**ADDENDUM  
NO. 2**

**KALAMAZOO PUBLIC SCHOOLS  
LOY NORRIX HIGH SCHOOL HEALTH SUITE  
606 East Kilgore Road  
Kalamazoo, MI 49001**

## ADDENDUM NO. 2

**PROJECT:** Loy Norrix High School Health Suite  
606 East Kilgore Road  
Kalamazoo, MI 49001

CLINIC DEMOLITION PLAN AND FLOOR PLAN

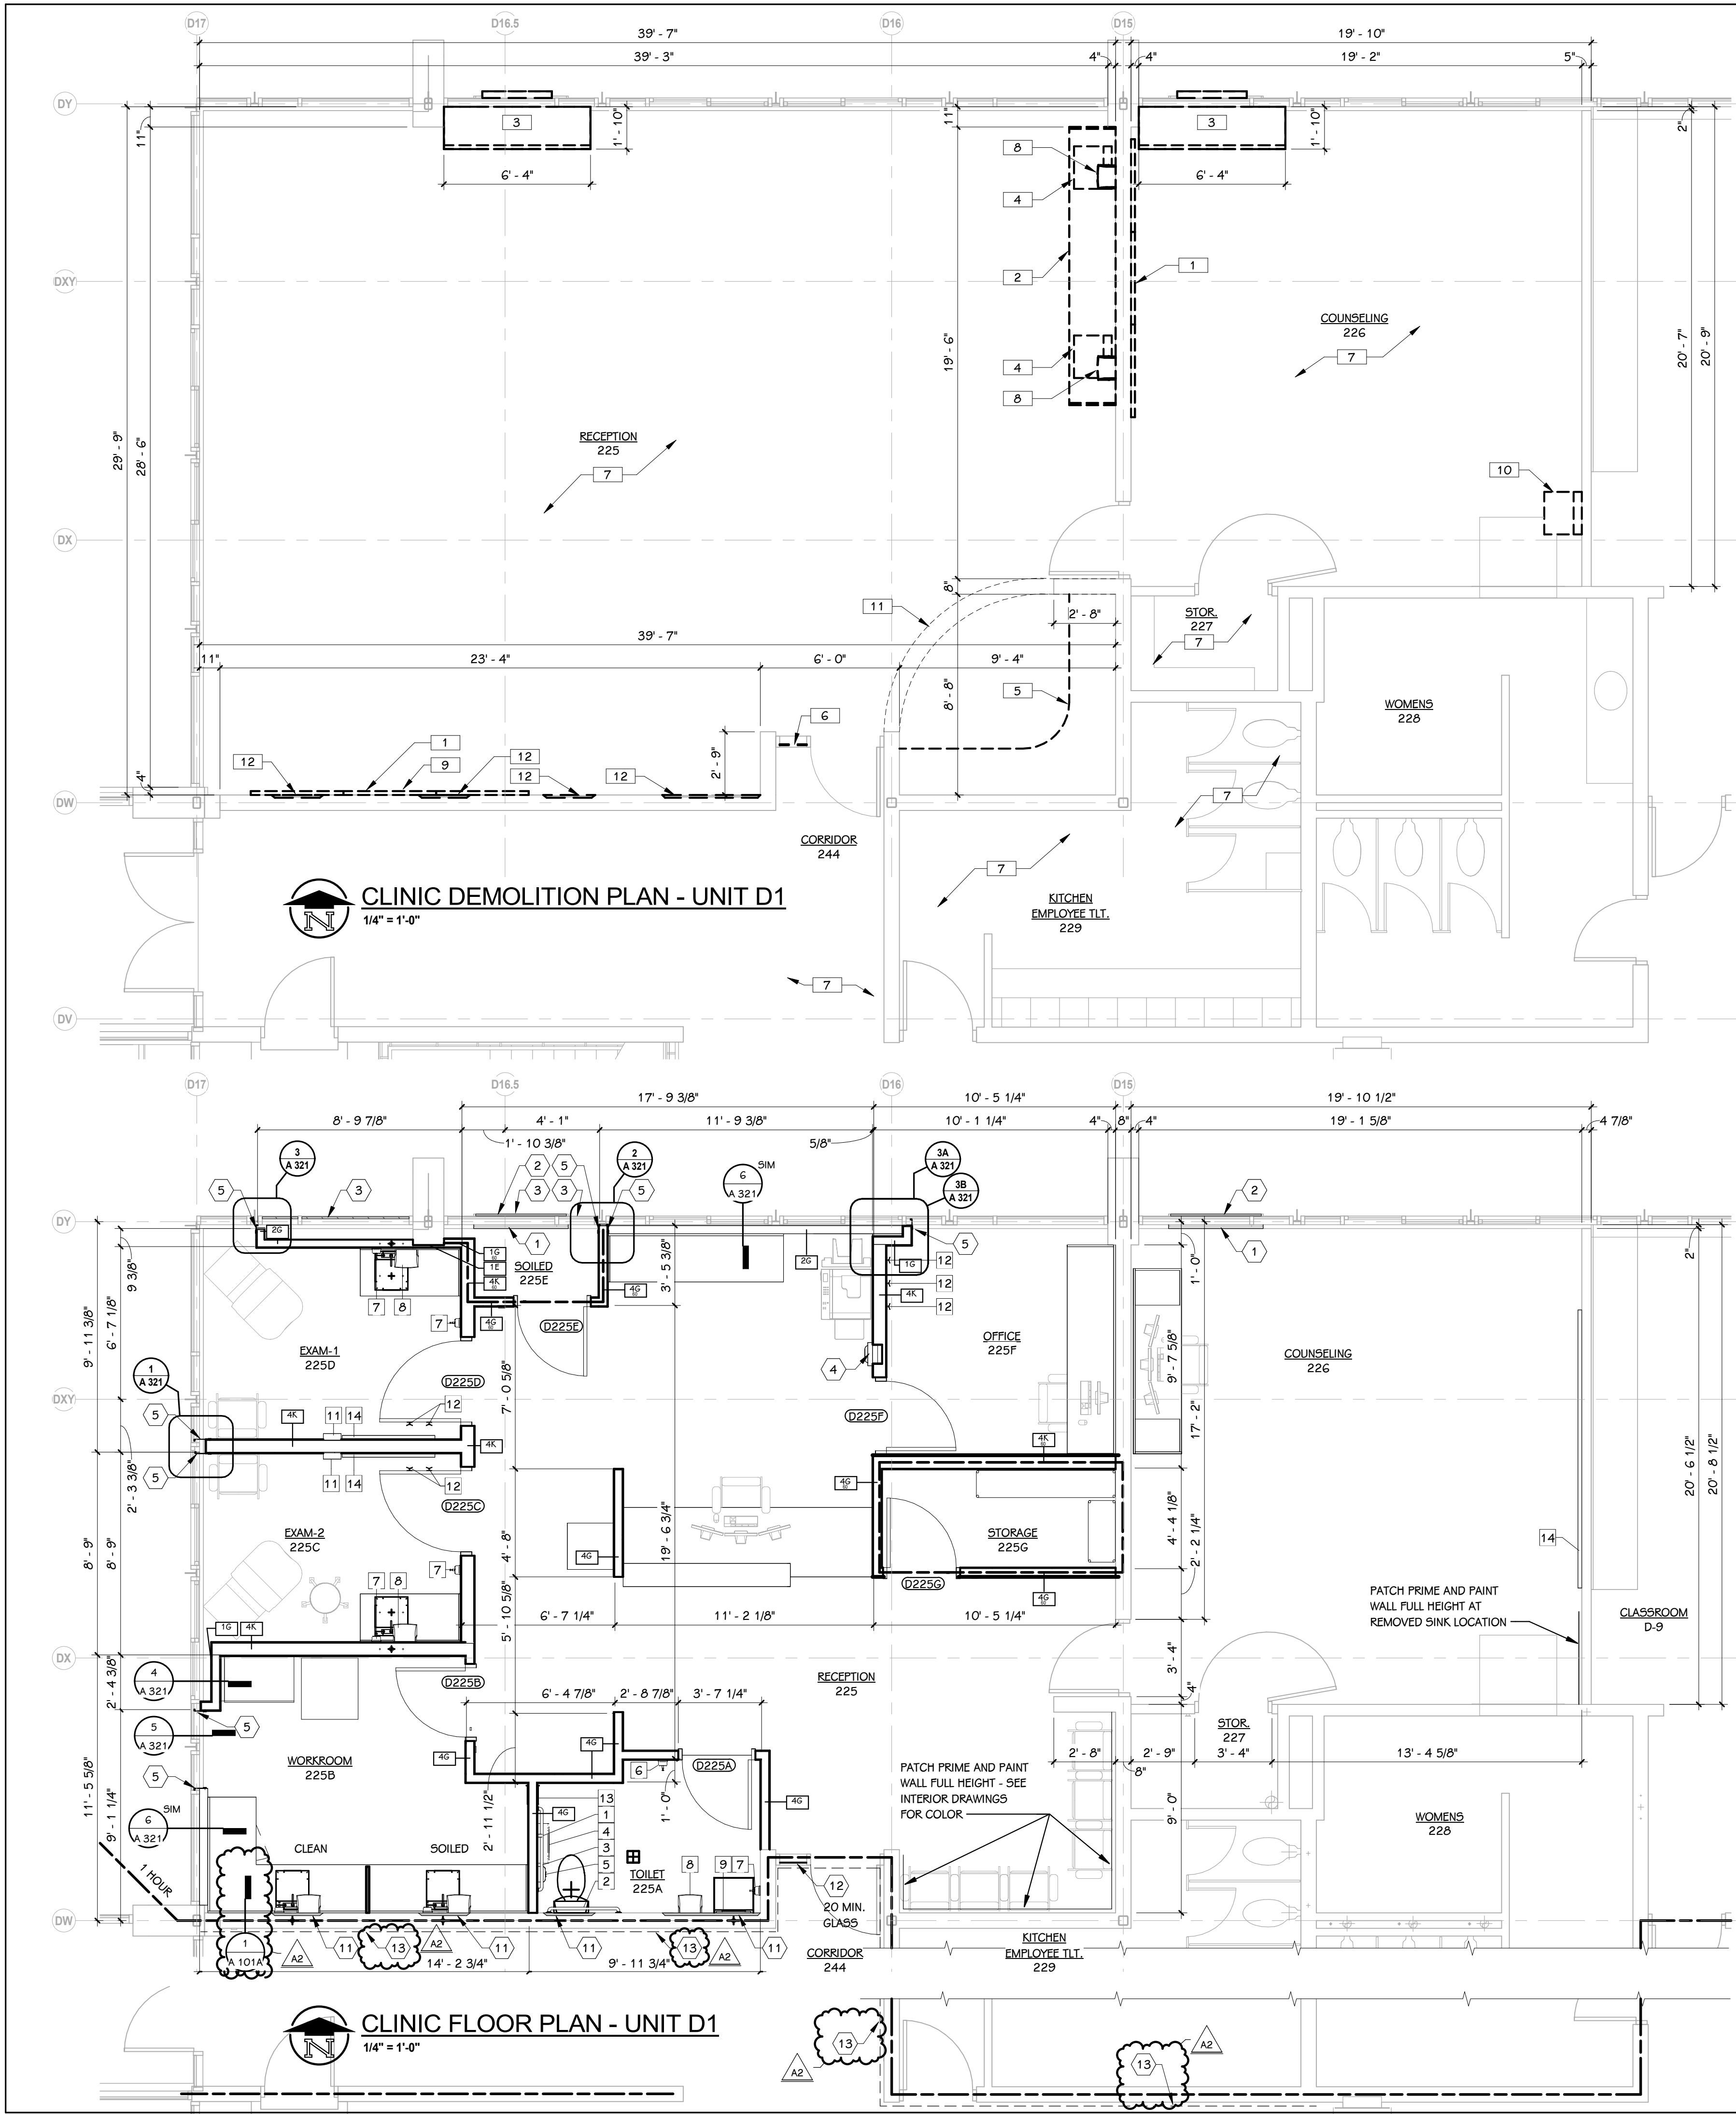
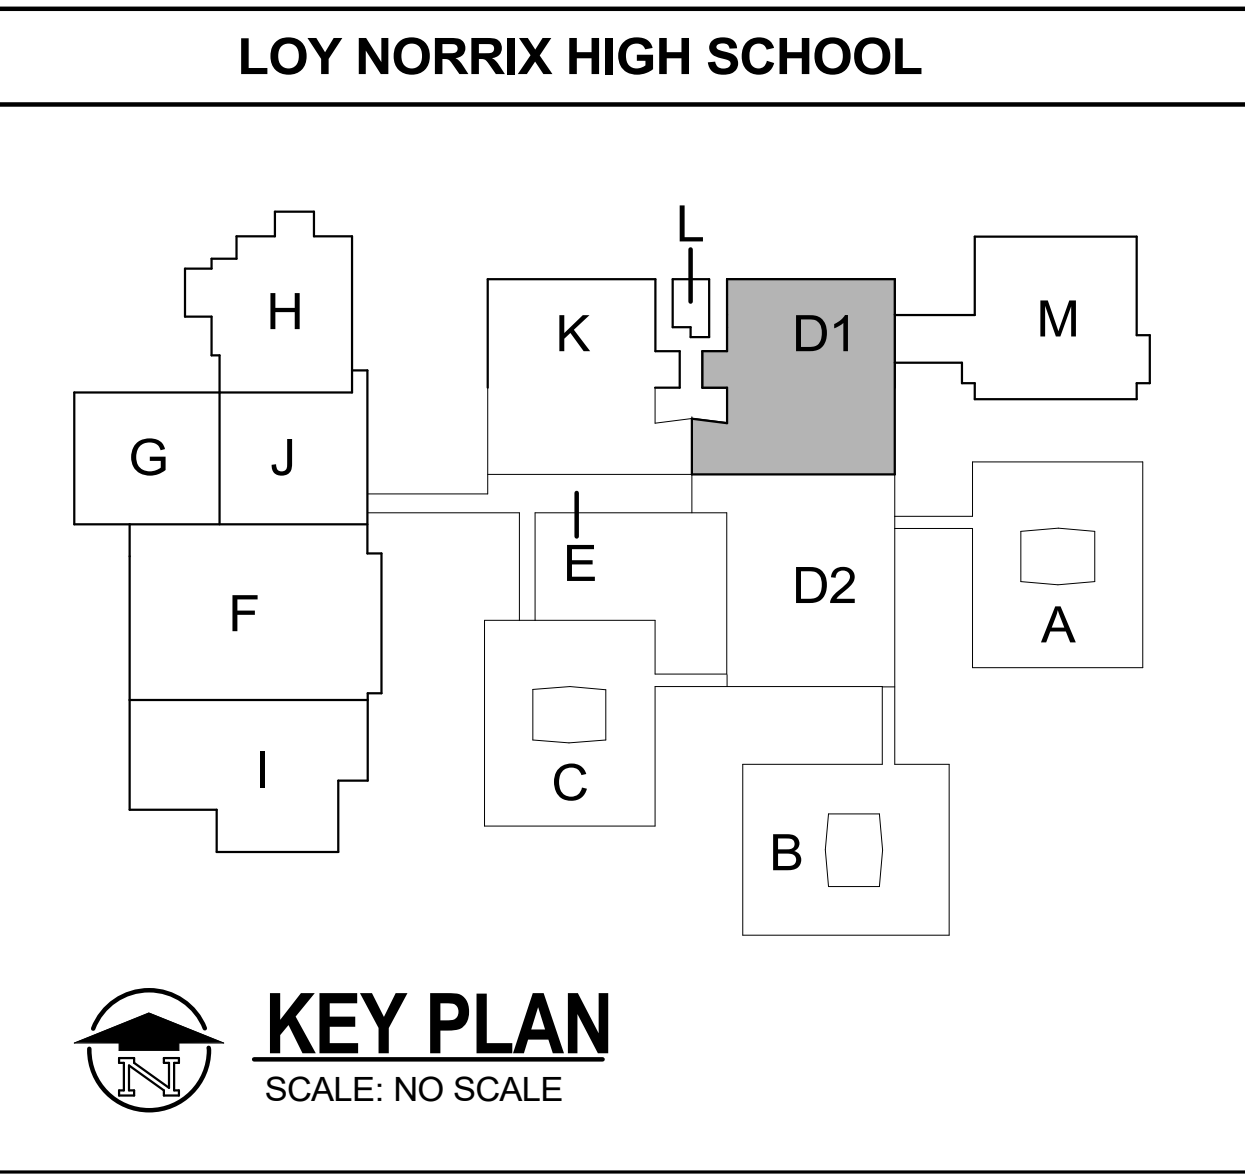
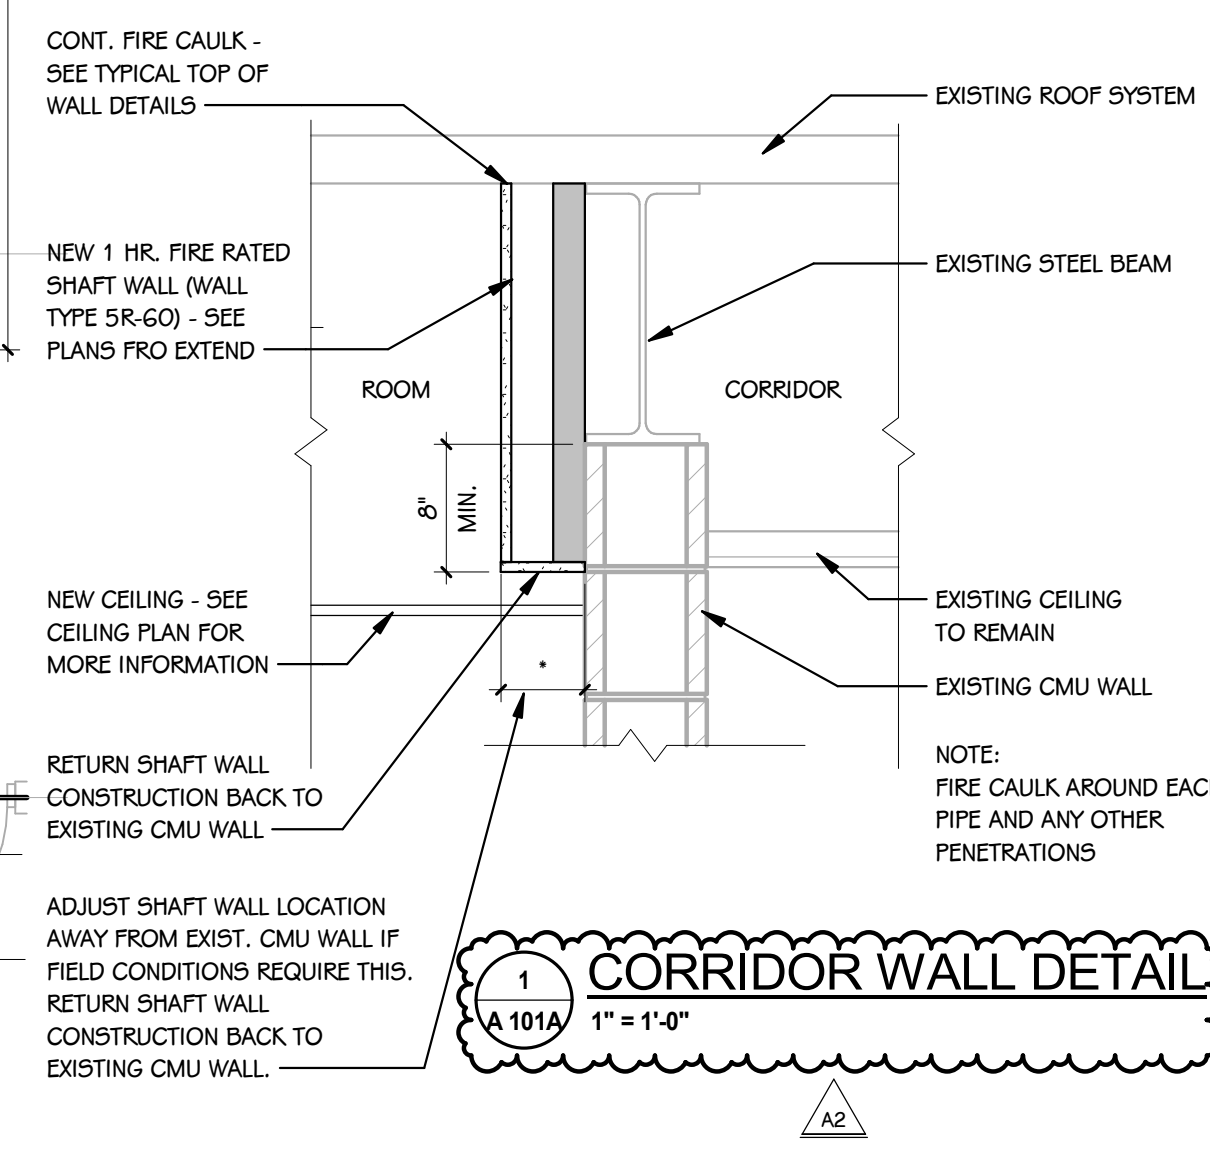
**ADD-2 Item No. D-2 - Corridor Wall Upgrades**

Refer to Sheet(s): A101A

Corridor wall at area of construction shall be upgraded to maintain an 1 hour fire separation. Added detail, and (new construction) keyed note, as well as floor plan updates to reflect this.

### TYPICAL STAINLESS STEEL LAVATORY SHIELD DETAIL

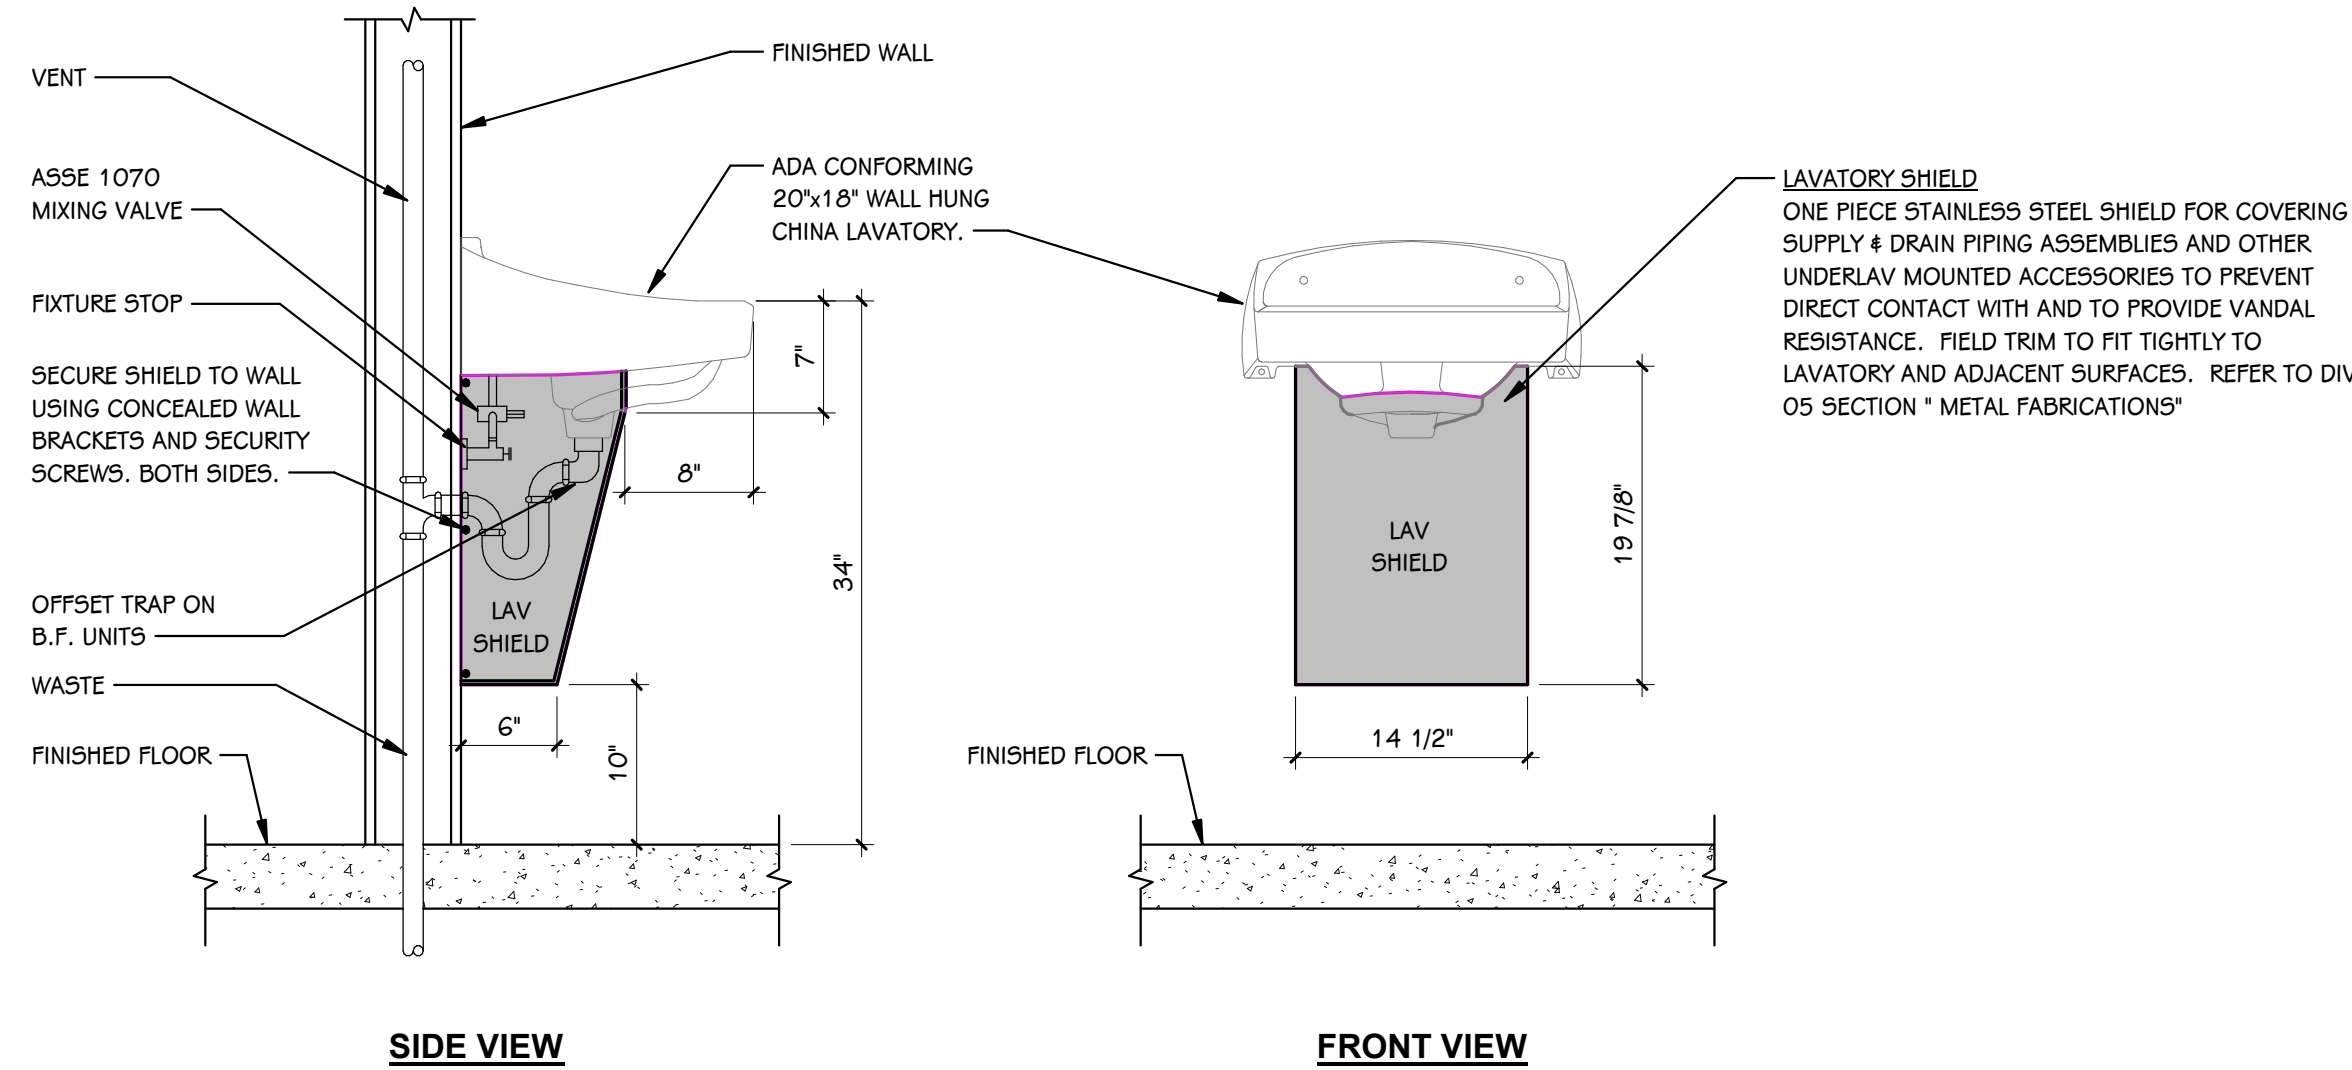
**ADD-2 Item No. D-1 - Typical Stainless Steel Lavatory Shield Detail**

Refer to Sheet(s): M502

Added “Typical Stainless Steel Lavatory Shield Detail”
